COUNCIL ASSESSMENT PANEL MEETING

BUSINESS ITEM – 9.1

Applicant: John Ellery	Landowner: J J Ellery & L Ellery
Agent: Urban and Regional Planning Solutions (URPS) – Philip Hartnett	Originating Officer: Melanie Scott
Development Application:	19/322/473
Application Description: Staged application for demolition of existing dwelling, community title land division (1 into 9) and construction of three (3) two storey dwellings & a two storey residential flat building comprising six (6) dwellings, removal of five (5) regulated trees (<i>Eucalyptus obliqua</i>) & one (1) significant tree (<i>Eucalyptus obliqua</i>), retaining walls (maximum height 2.8m), combined fence & retaining walls (maximum height 4.7m), landscaping including replacement plantings & associated earthworks: Stage 1 - Demolition and tree removal Stage 2 - Driveway construction and civil works Stage 3 - Construction of dwellings on lots 1, 2 & 3 Stage 4 - Construction of residential flat building (dwellings on lots 4 to 9) and remainder of works

AMENDED Description: Staged application for demolition of existing dwelling, community title land division (1 into 8) and construction of three (3) two storey dwellings & a two s

DRAWING TITLE
Elevations

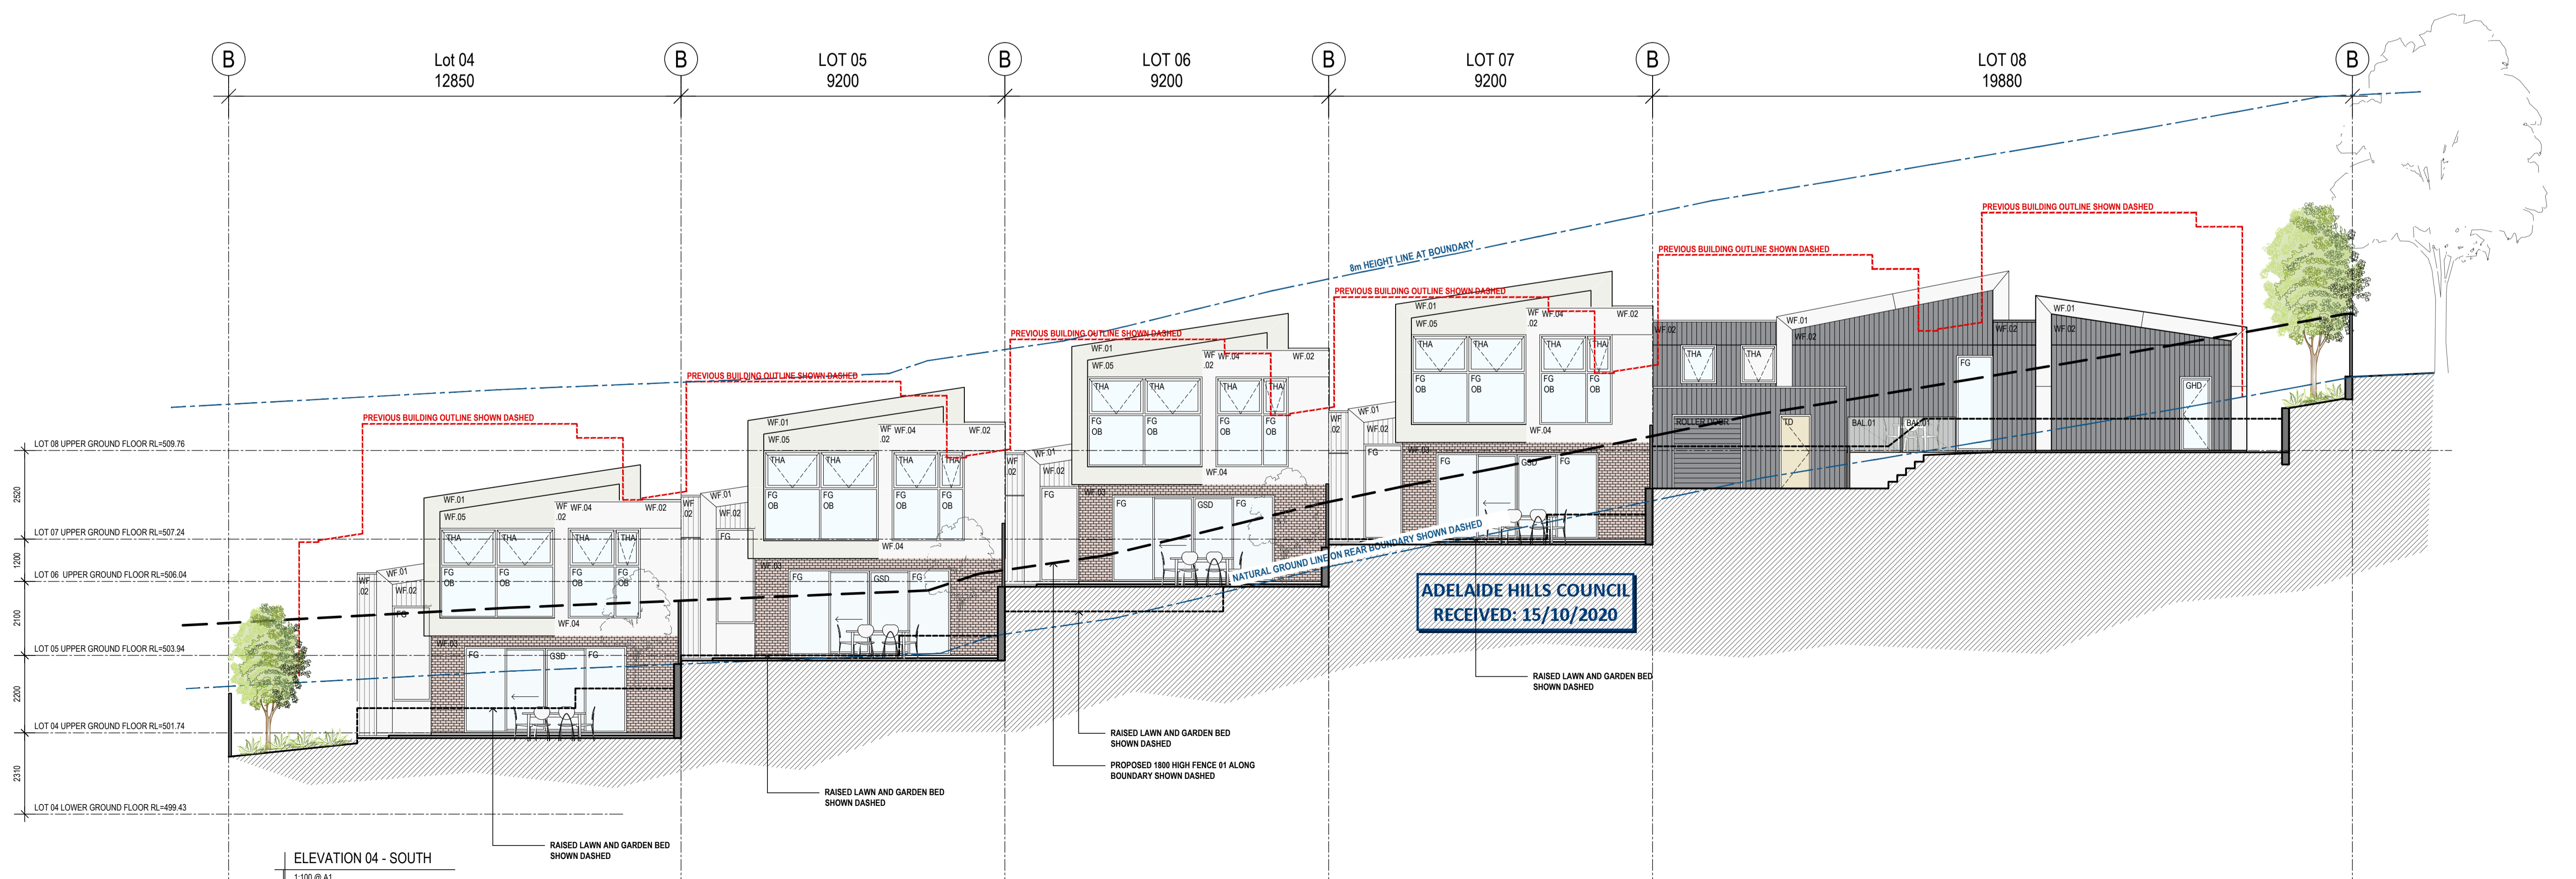
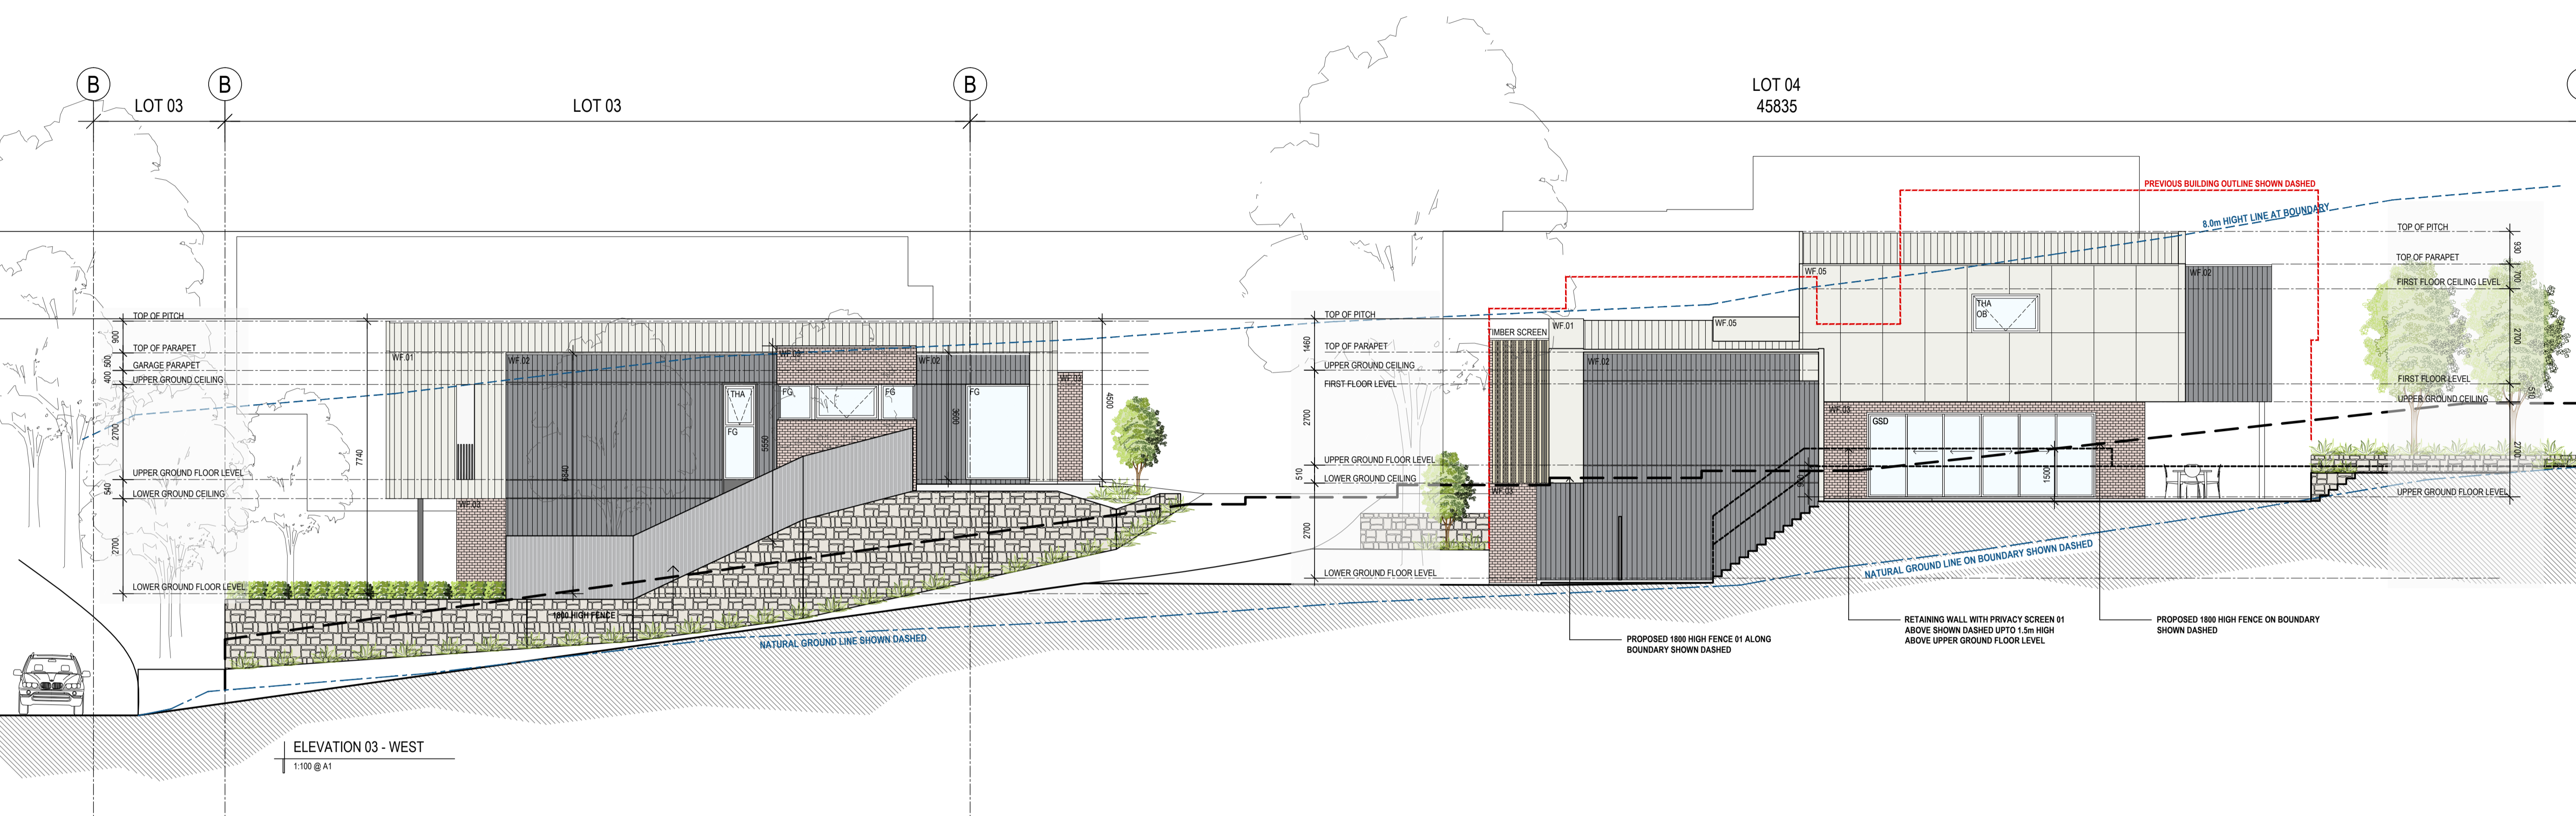
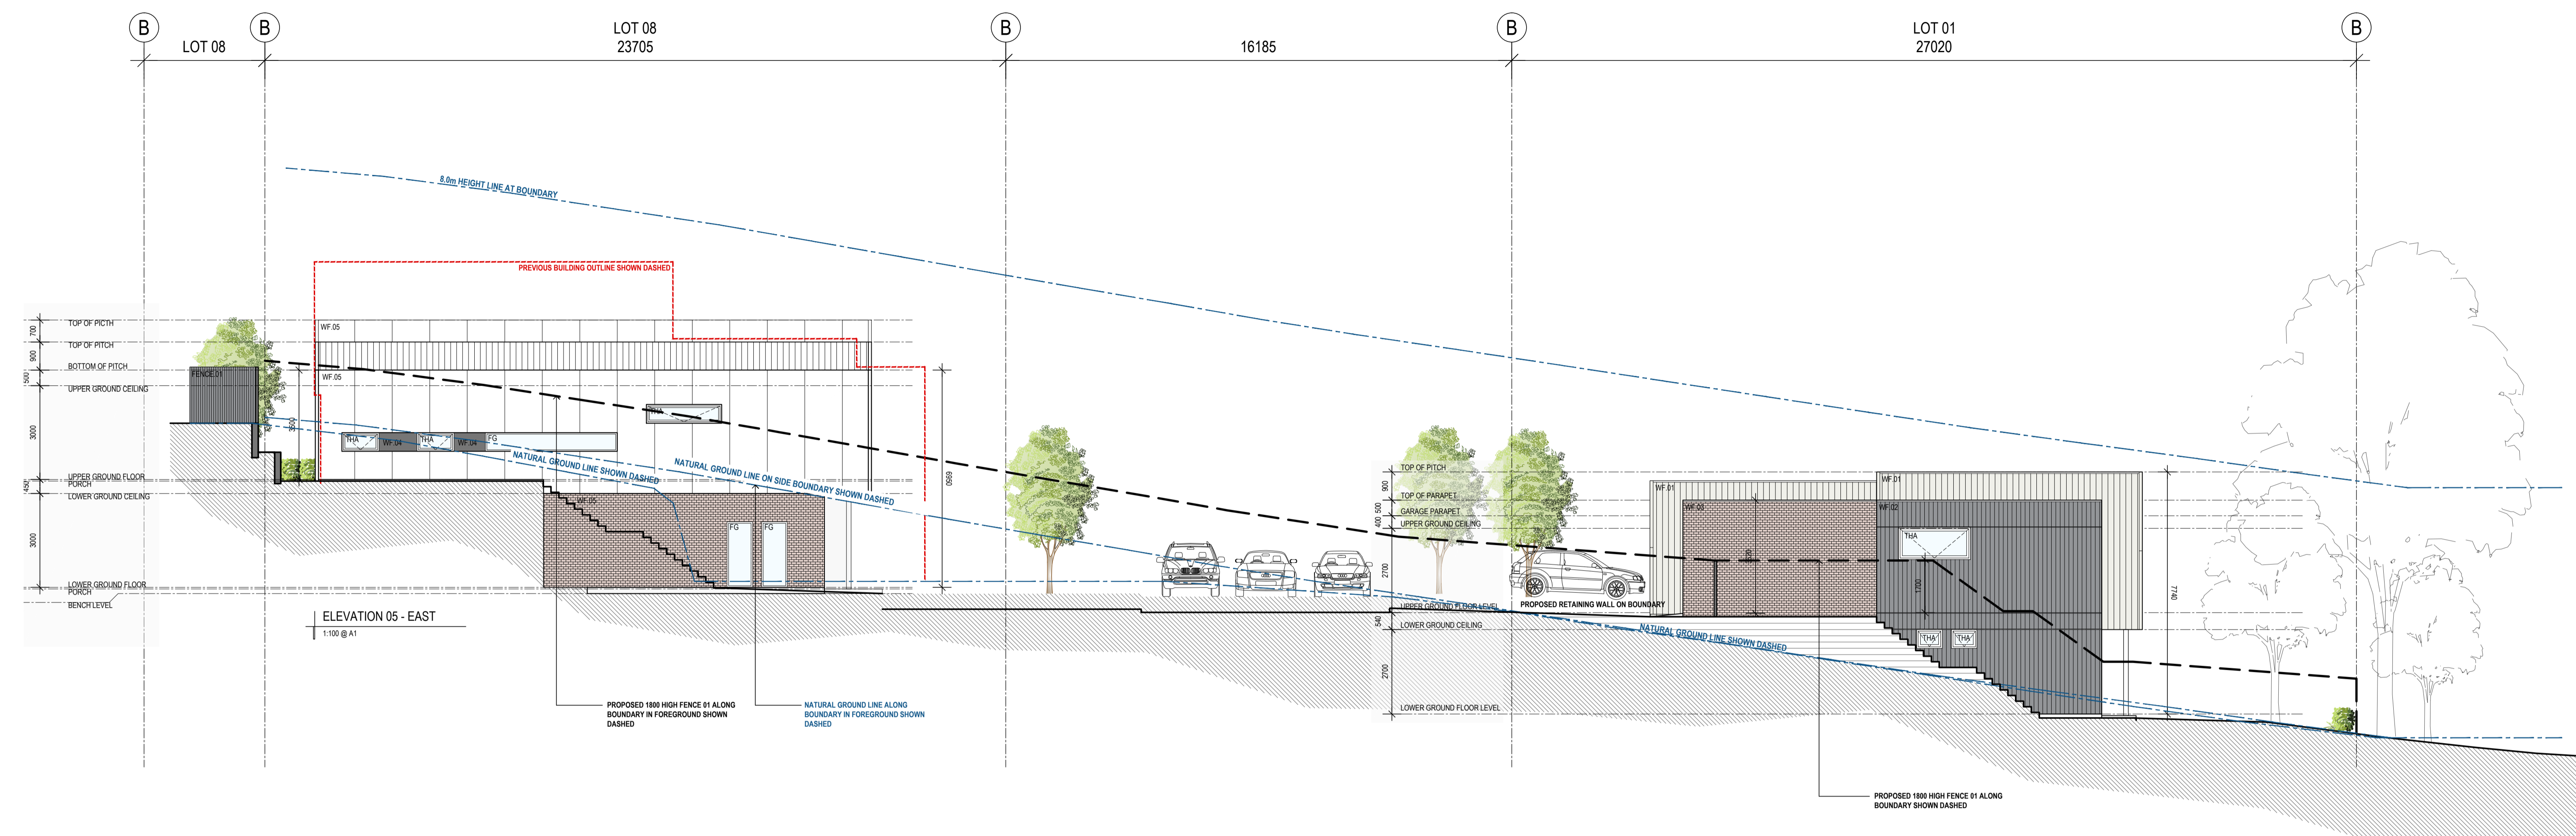
With regards to bulk and scale, the amended proposal still has the consequence of the proposed structures presenting as a four storey development when viewed from Pomona Road (see elevation drawing 18-015.PL06.H) at the eastern portion of the site. However, the change in the roof to a skillion design combined with the general lowering of the residential flat building into the site and the reduction in the number of lots and dwellings has reduced the overall bulk and scale of the amended proposal.
